Item Name: Replacement Skidtube

DESIGN		**DART AEROSPACE LTD**	
DRAWN	RF	HAWKESBURY, ONTARIO, CANADA	
CHECKED		DRAWING NO.	REV. E
MFG. APPR.		D2580	SHEET 1 OF 8
APPROVED		TITLE	SCALE
DE APPR.		205 SKIDTUBE ASSEMBLY	NTS
DATE	11.06.21

DRAWING NO.	TITLE	REV. E	DART AEROSPACE LTD	D.E.O. NO.	SHEET NO.	SCALE
D2580	205 SKIDTUBE ASSEMBLY		ENGINEERING ORDER	D2580-E-1	SHEET 1 OF 1	NTS

PURPOSE:
CHANGE ALL C'BORED WELDED CROSSBOLT SPACERS TO SWAGED SPACERS

SECTION B-B, F-F, I-I
NOT TO SCALE

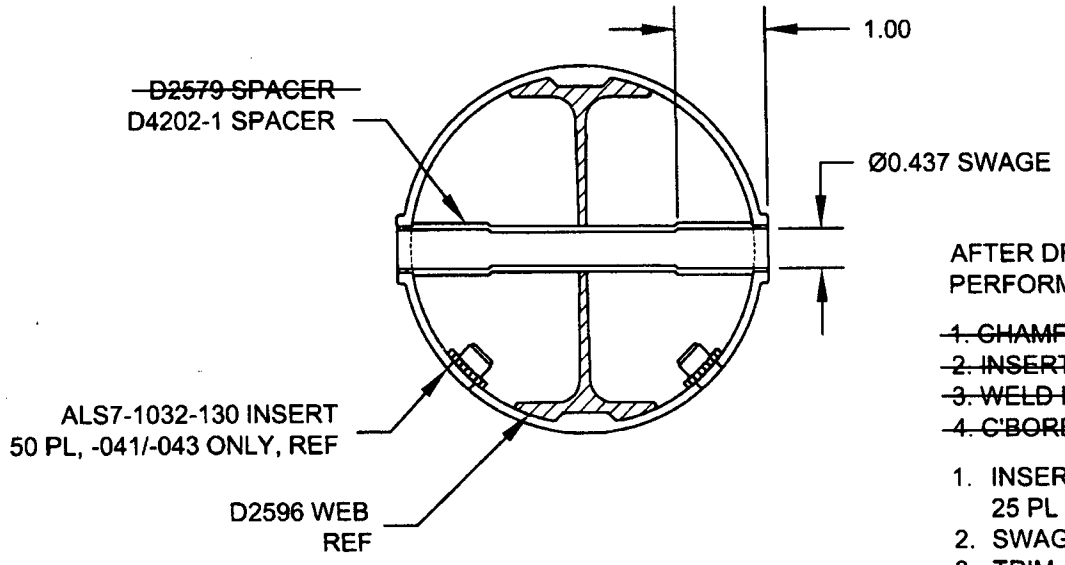
SECTION B-B, SECTION F-F, & SECTION I-I ARE AMENDED AS FOLLOWS
FOR ALL HOLES THAT WERE ORIGINALLY C'BORED:

CHANGE:
PARTS LIST IS AMENDED AS FOLLOWS:

4		* D2579	CROSS BOLT SPACER
20	20	25	D4202-1	SPACER

*** FOR -045 SKIDTUBE ONLY:**
WELD 4X D2579 SPACERS PER DWG
IN LOCATIONS MARKED **"NO C'BORE".**
REF SHEET 4 OF DWG.
